ADDENDUM NO. 1

Date: January 29, 2026
Project Name: East Side Hangar Access Taxilanes (Phase II)
Owner: Fort Worth Spinks Airport (FWS)
TxDOT CSJ No.: 2602SPINK
Garver Project No.: 2401096

CONSTRUCTION SAFETY AND PHASING PLAN (CSPP) - PAGE 2 OF 2

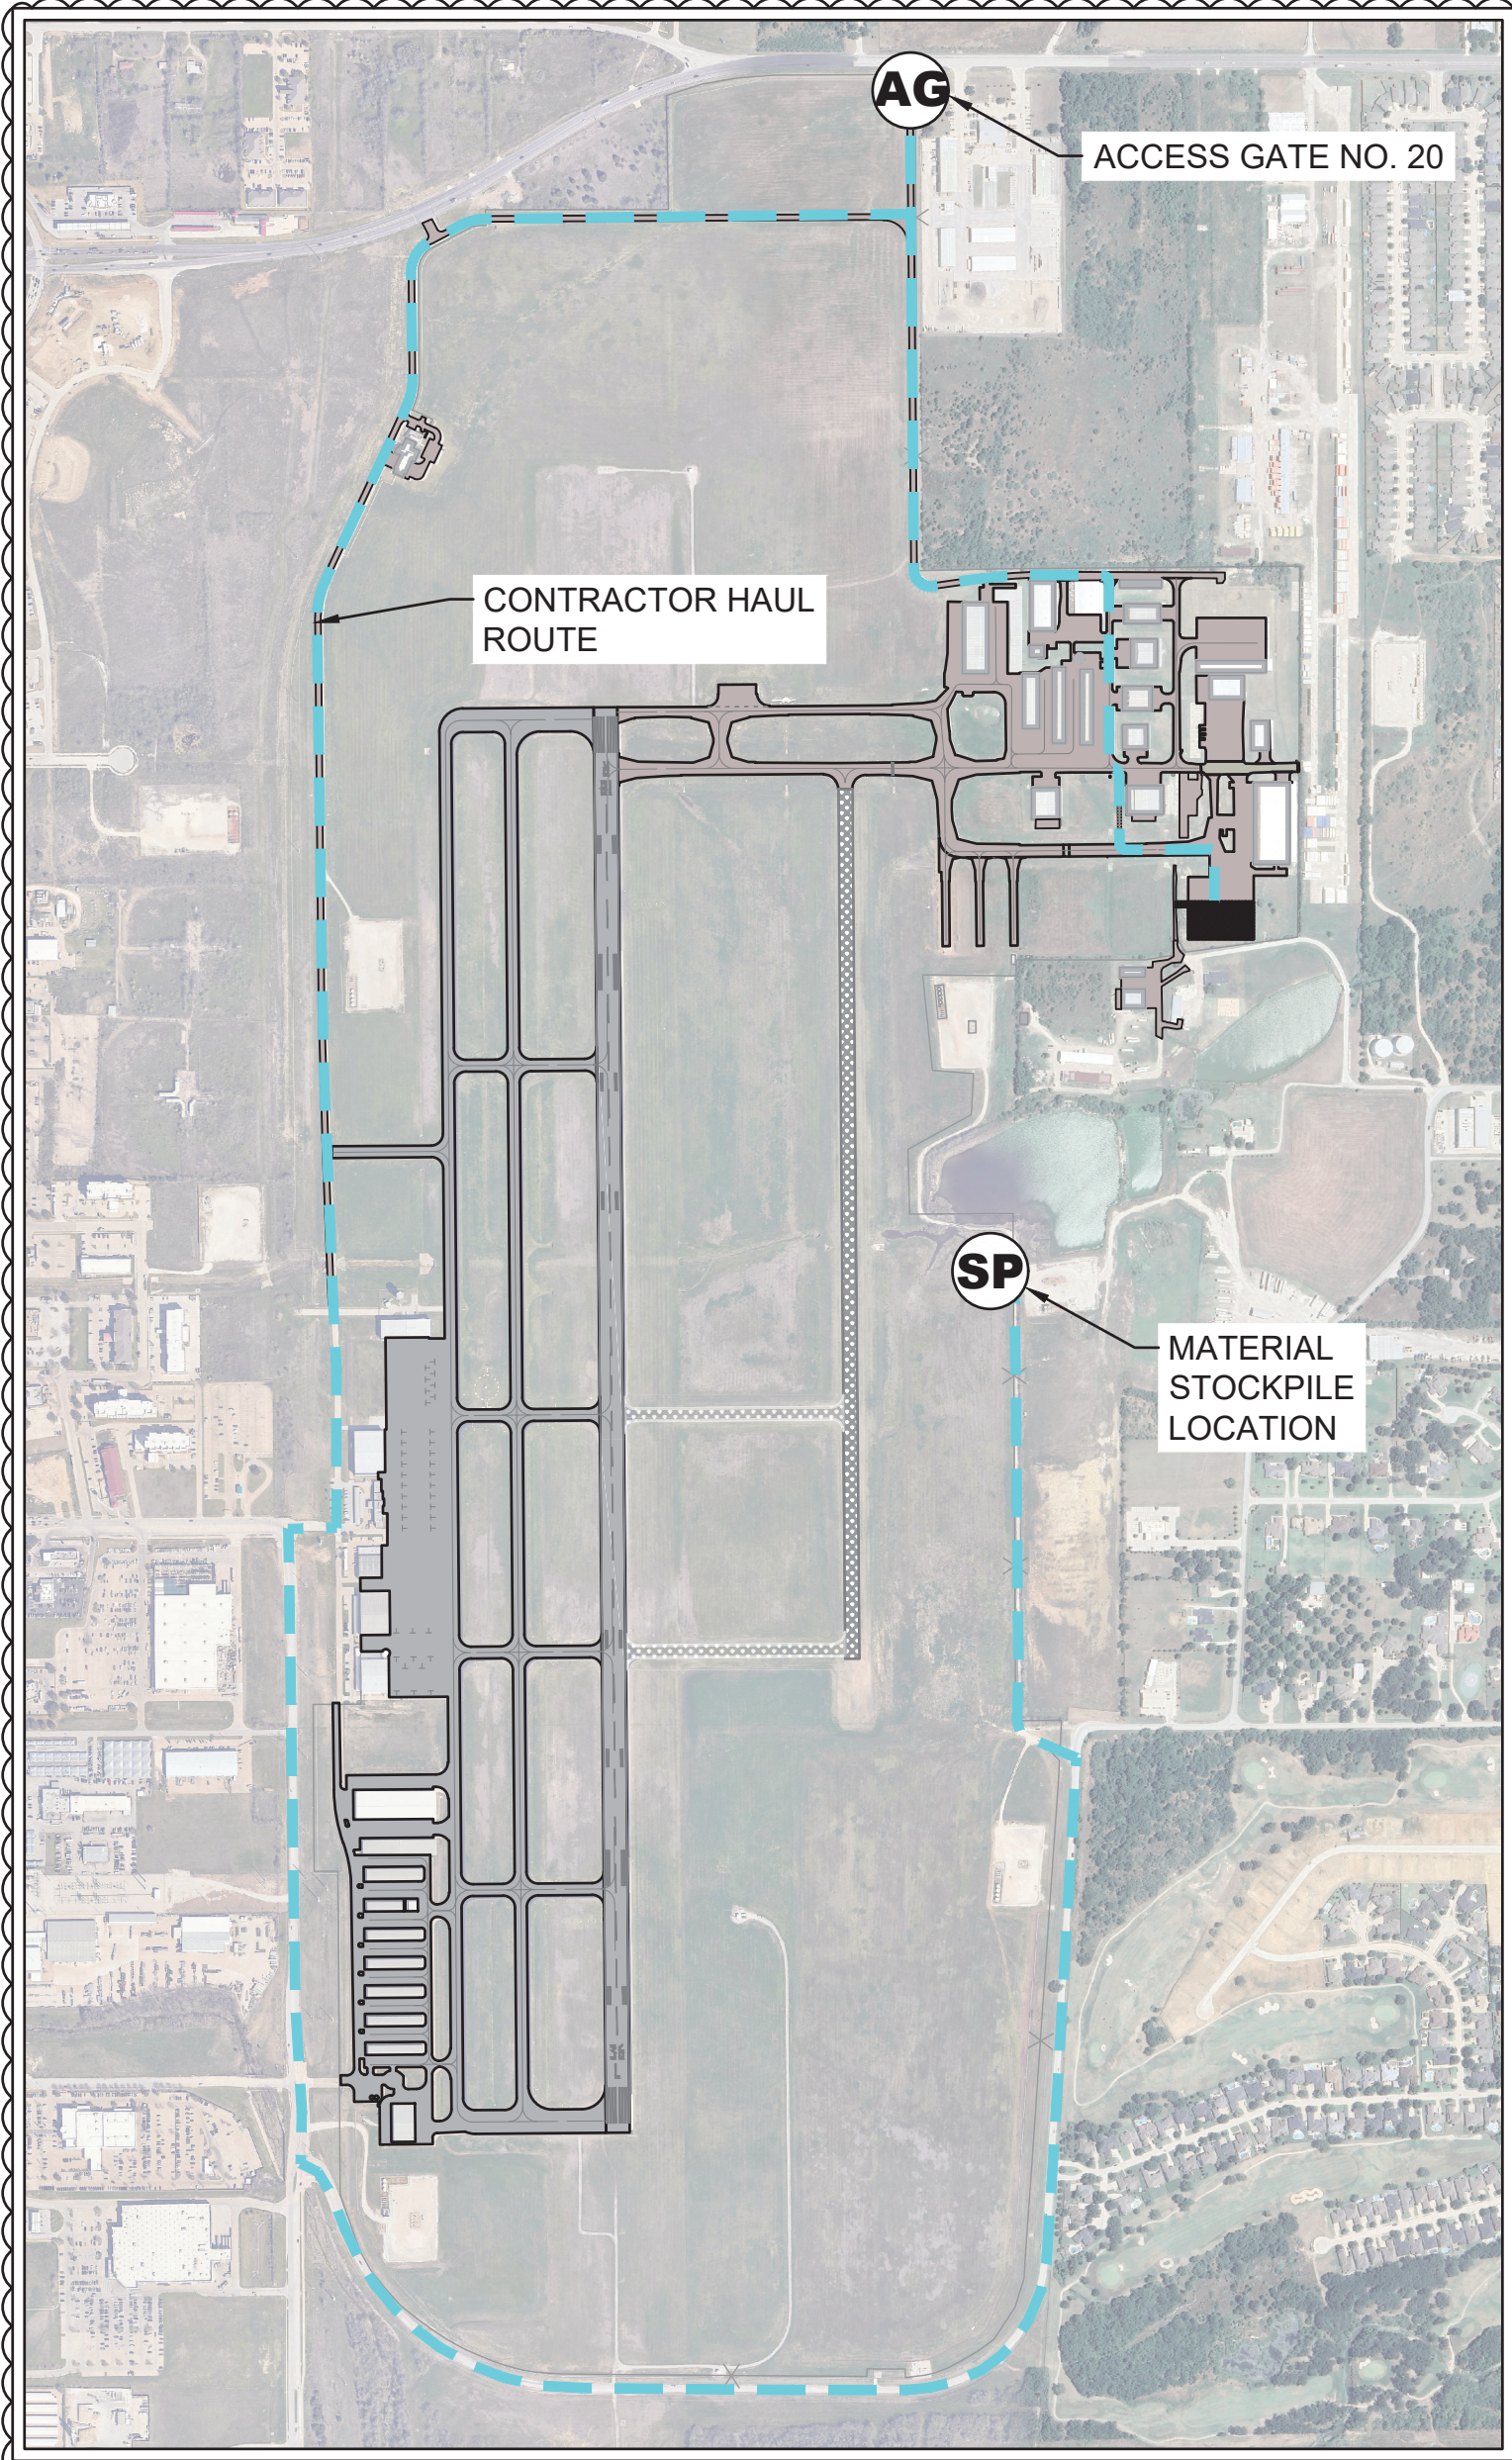
- a. Replace the existing sheet "CG-002" with revised sheet "CG-002" to include inset view for haul route to stockpile location.
- b. Replace the existing sheet "CP-001" with revised sheet "CP-001" for revised details.

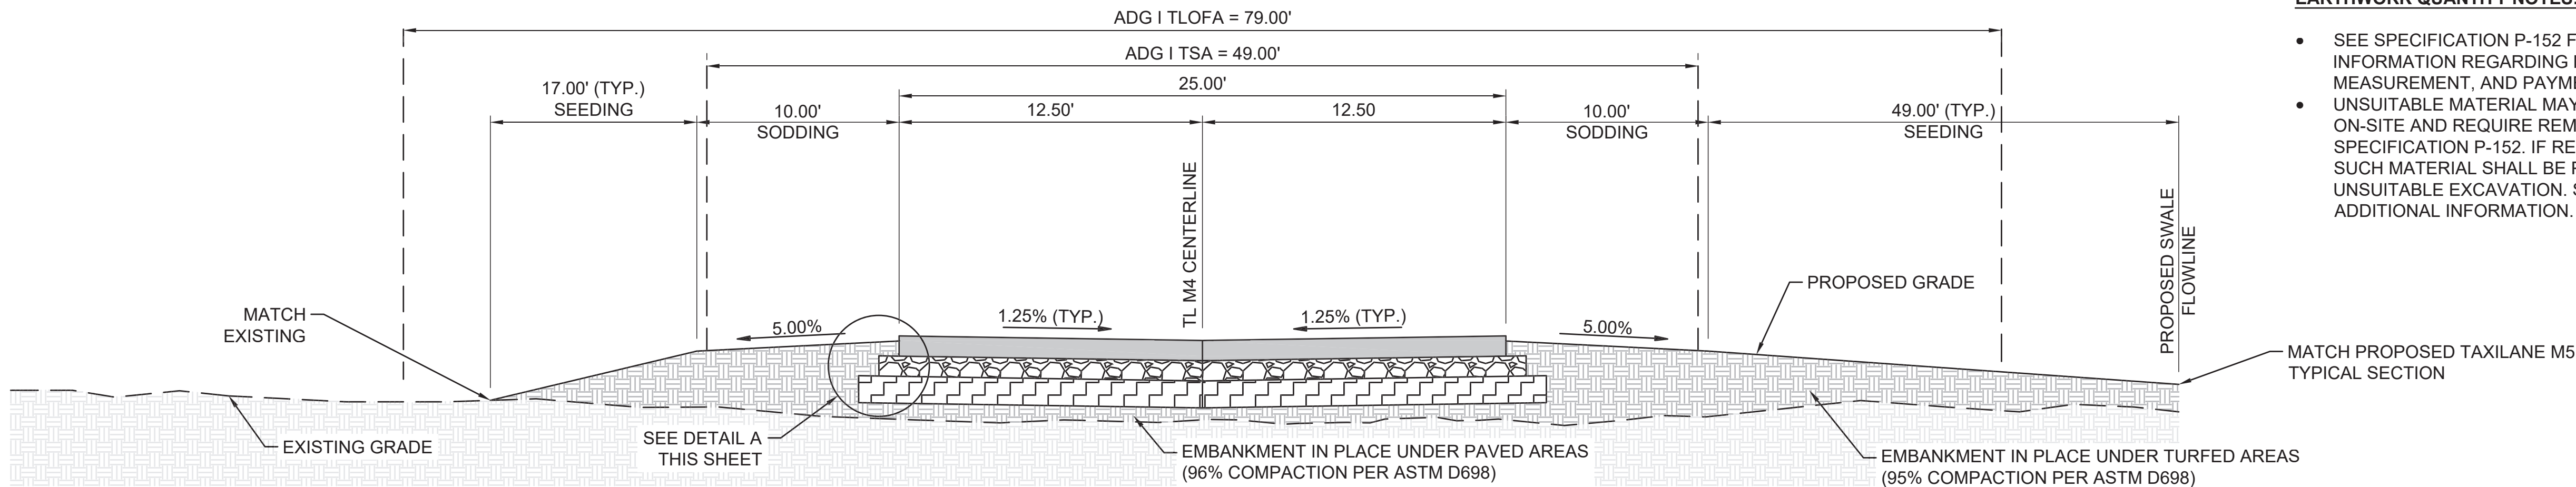
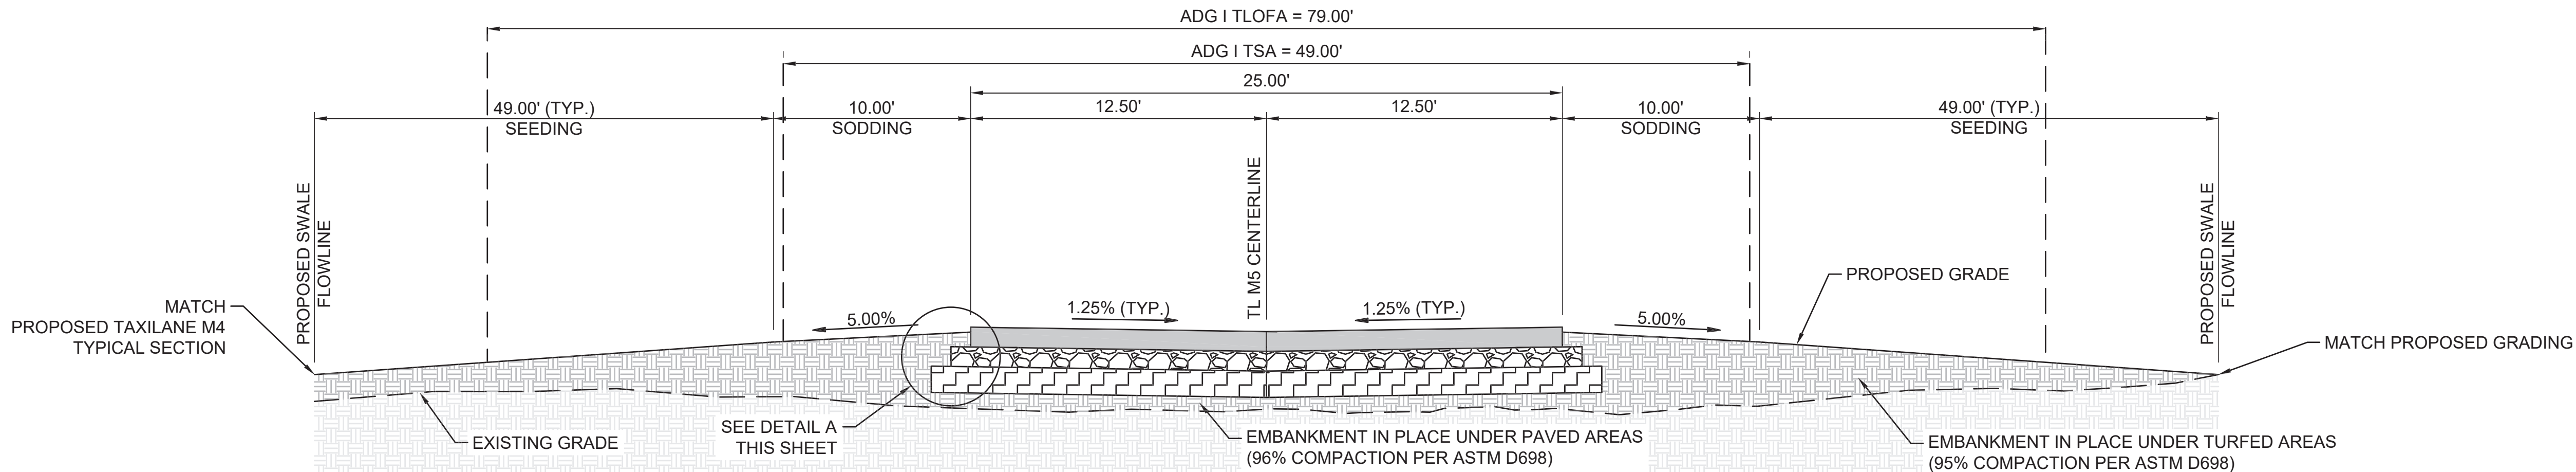
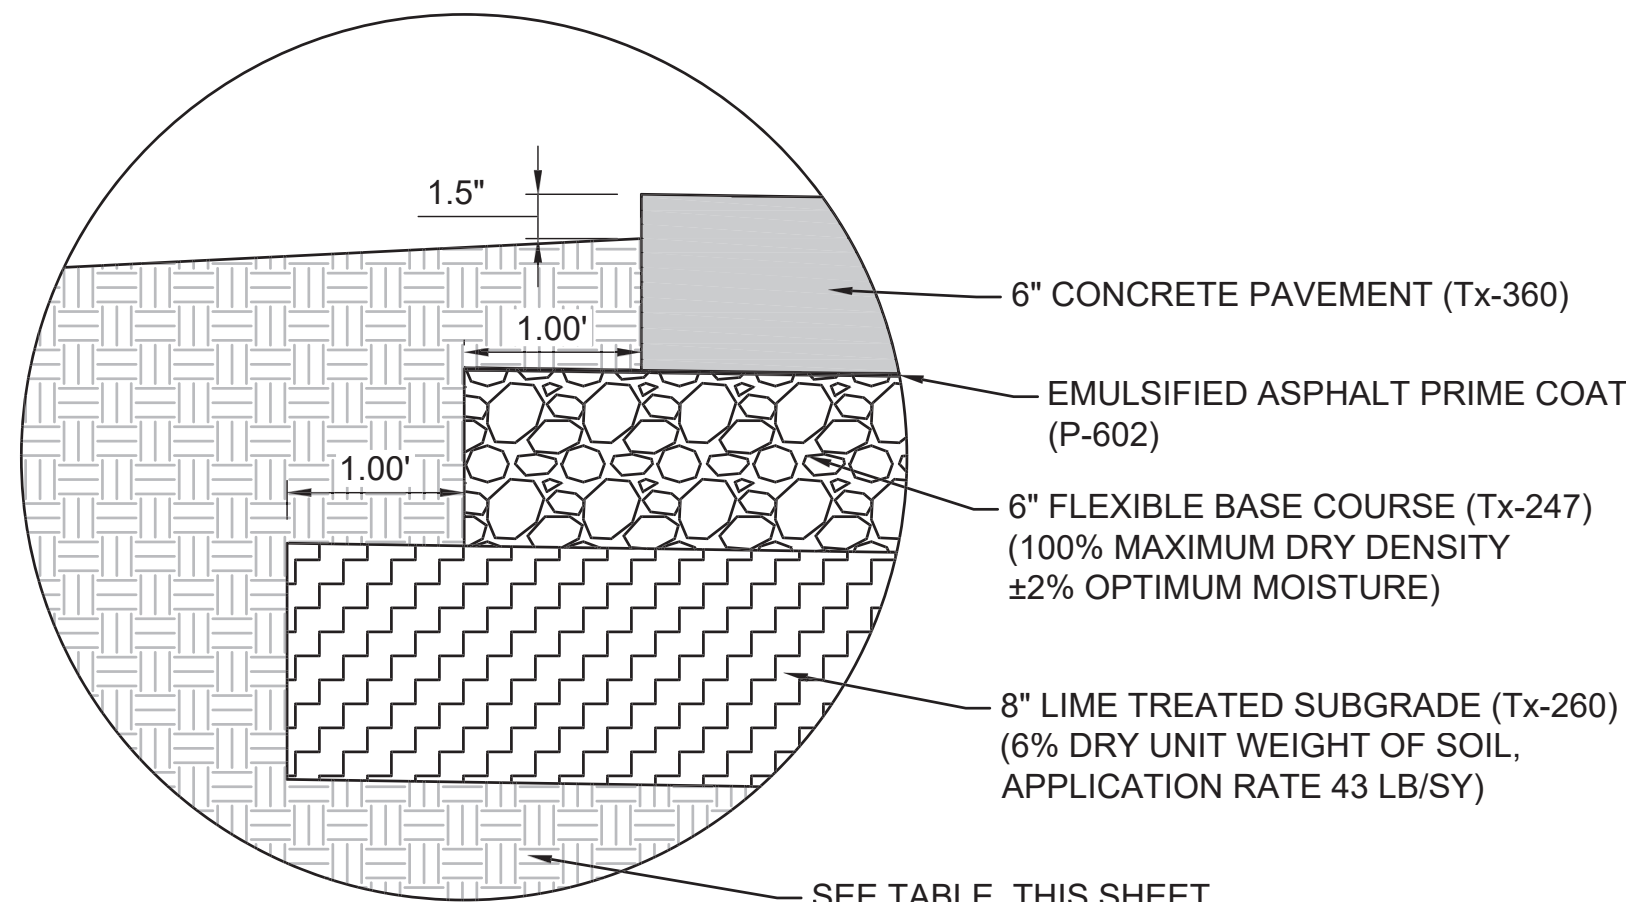
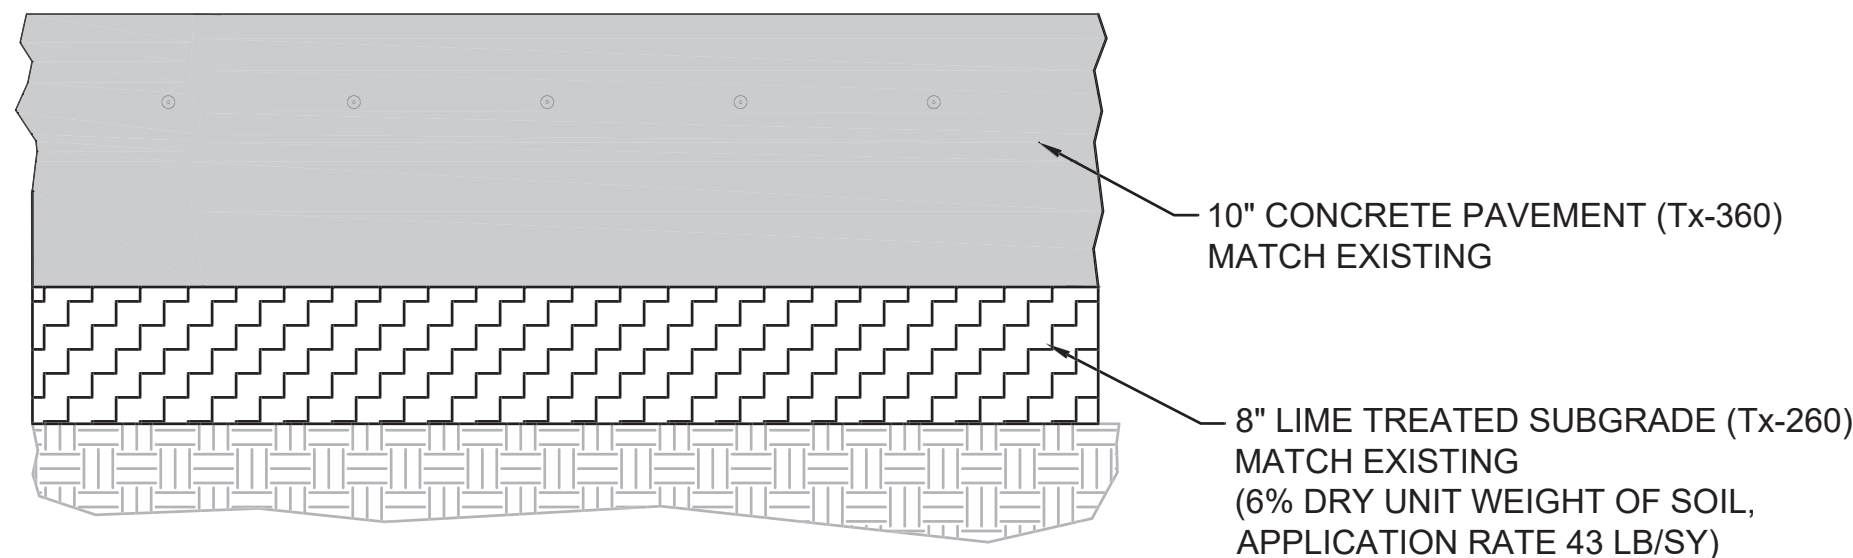
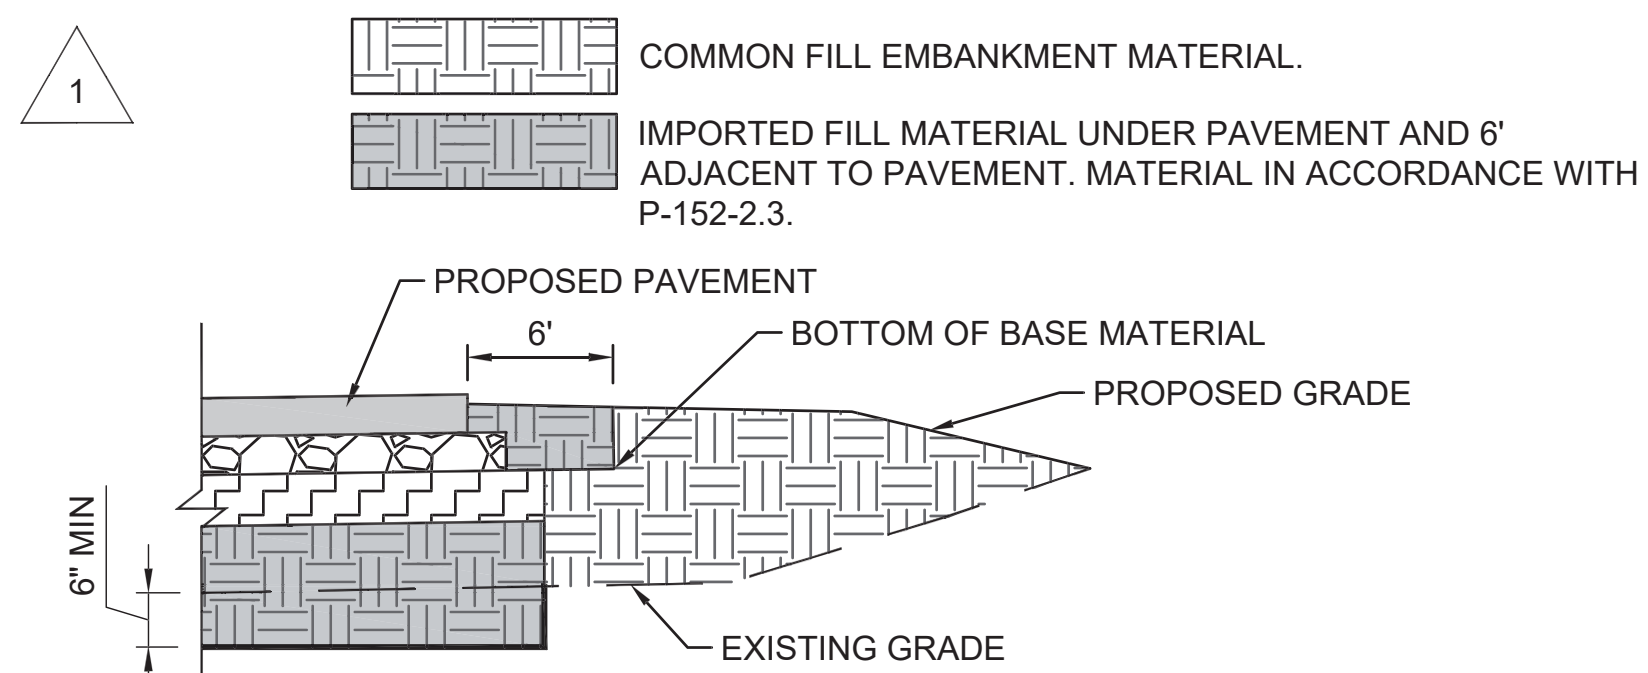
- i) No, imported "select" fill material will only be required under pavement areas and 6' adjacent to pavement areas. See detail 4 on sheet CP-001 for required locations of imported fill material.

- CONTRACTOR SHALL REMOVE A MINIMUM OF 6" OF THE EXISTING SOILS BELOW THE PROPOSED PAVEMENT SECTION PRIOR TO INSTALLING IMPORTED FILL.
- COMMON FILL MATERIAL MAY BE OBTAINED FROM EXCESS CUT WITHIN THE PROJECT LIMIT. NO OTHER BORROW AREAS EXIST ON AIRPORT PROPERTY FOR THIS PROJECT.
- COMMON FILL MATERIAL MAY CONSIST OF SOILS THAT HAVE A PI EQUAL TO OR GREATER THAN 35. MATERIAL SHOULD BE COMPACTED TO AT LEAST 95% MAXIMUM DRY DENSITY AND BE WITHIN +/- 2% OPTIMUM MOISTURE CONTENT.
